ANC 3

MEMORANDUM

Subject: **General Discussion of the Assessment of the Serviceability of the Oyster Creek Nuclear Generating Station Drywell Liner in Light of New Information Contained in recent AmerGen Submissions to the NRC and the ASLB.**

Figure 1

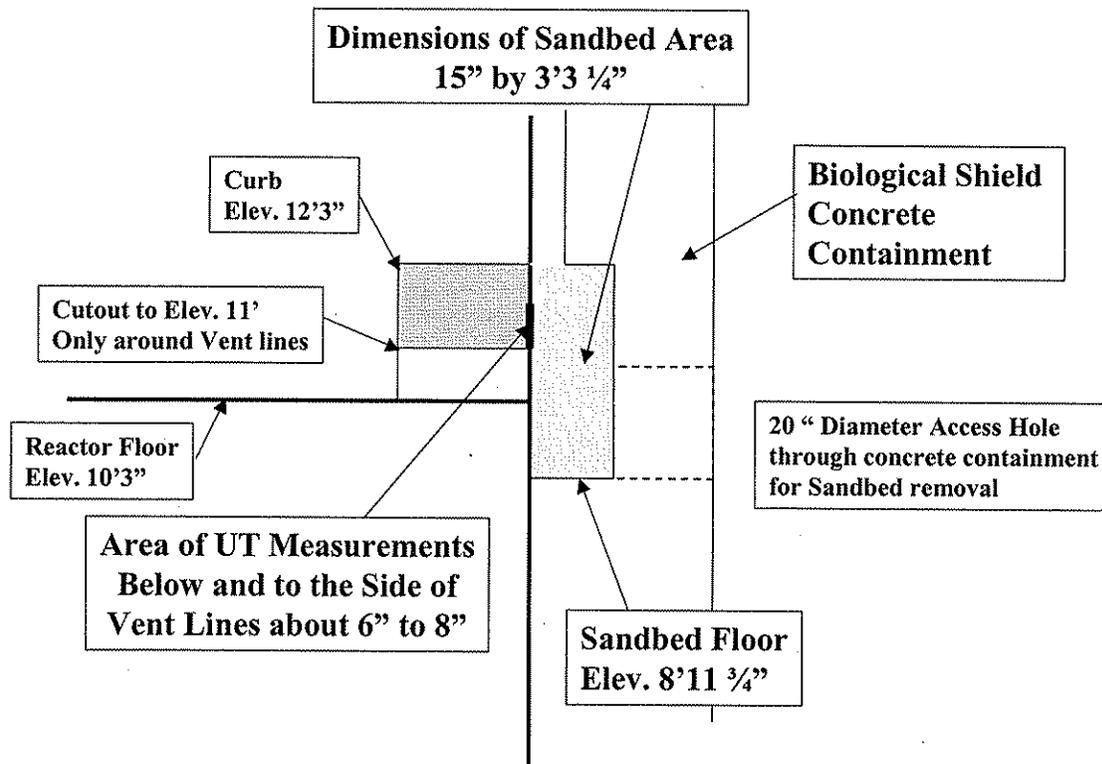
(It should be noted that all the measurements regarding the depth of the trenches relative to the sandbed floor are nominal, i.e. according to the drawings (Fig. 1). Since it had been found that the sandbed drains were 6 to 8 inches above the floor one

might justifiably ask the question whether the floor was at the correct elevation to begin with. Data like these have never been properly verified even after the sandbed had been removed and the floor had been found to be in a bad condition.)
